# Planning & Zoning Commission

## CWP DUBLIN 23-010INF

Address	435 Metro Pl. S., Dublin, Ohio 43017
Proposal	Conversion of an extended stay hotel to multi-family apartments. The 4.077-acre site is zoned PUD, Planned Unit Development District - Waterford Village, and is located approximately 170 feet southwest of the intersection of Metro Place S. and Frantz Road.
Request	This is request for an informal review and feedback of a future development application.
Zoning	PUD, Planned Unit Development District – Waterford Village
Planning Recommendation	Consideration of the discussion questions.
Next Steps	Upon receiving feedback from the Planning and Zoning Commission, the applicant may incorporate the feedback and submit a Rezoning/Preliminary Development Plan for formal review.
Applicant	Asaf Fligelman, Churchwick Partners Jonathan Schwalb, Churchwick Partners
Case Manager	Zach Hounshell, Planner II (614) 410-4652 zhounshell@dublin.oh.us

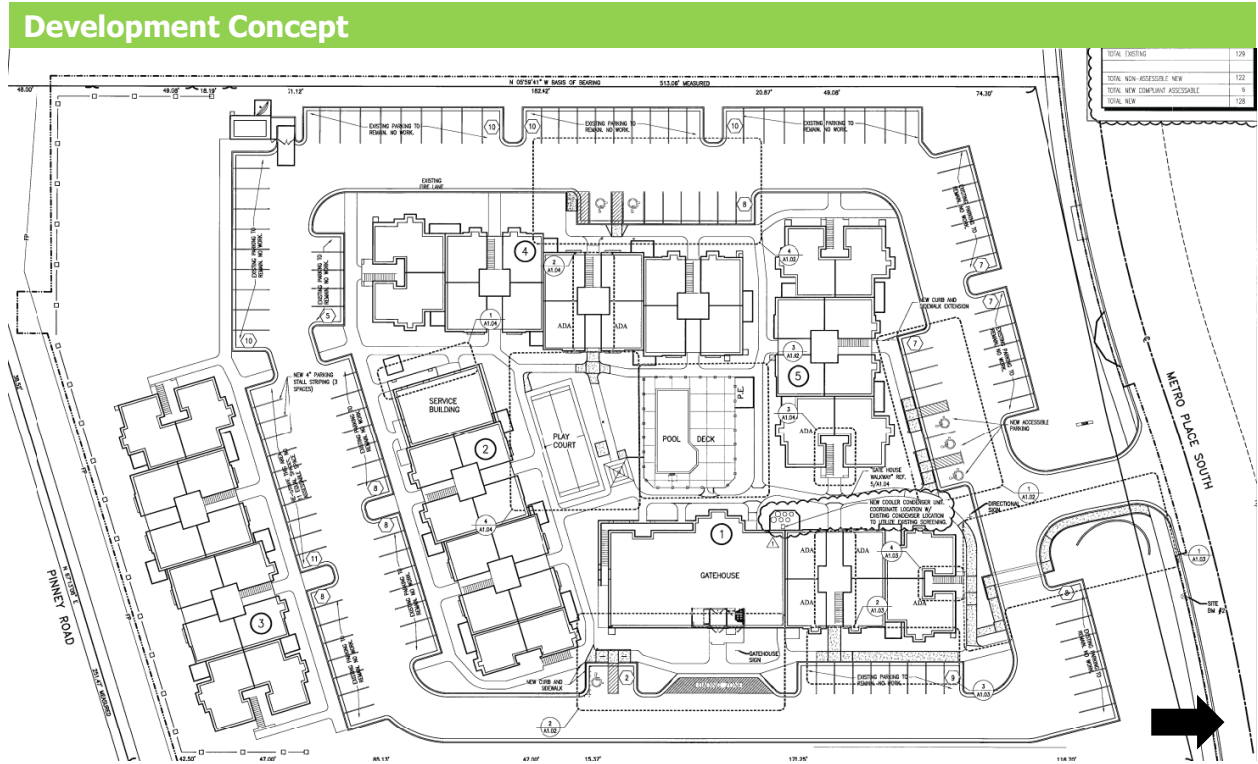
The FLU recommendation for the site is MUR-1 – Metro/Blazer. In detail:

*The Metro/Blazer Sub-District exemplifies the challenges of the "legacy" office development pattern. Once a premier office district in all of central Ohio, this district now has a competitive disadvantage compared to more newly developed office areas, due to a lack of amenities, low walkability, and an outdated appearance. In addition, there are practical difficulties for site access, inefficient parking and site design that must be remedied. This sub-district does have great promise due to the excellent location and significant amount of Frantz Road frontage. The introduction of a mix of uses, additional roadway connections, and strategic phased redevelopment will reposition this sub-district to succeed for future generations. Appropriate uses include office, residential infill on key sites and mixed-use development along Frantz Road. Road extensions should be explored, linking Metro Place South and Blazer Parkway, as well as Metro Place North with Shier Rings Road. Uses for this sub-district include: office, research and*

development, personal services, retail, restaurant/bar, entertainment, hotel, and multi-family residential (discouraged along I-270 frontage).
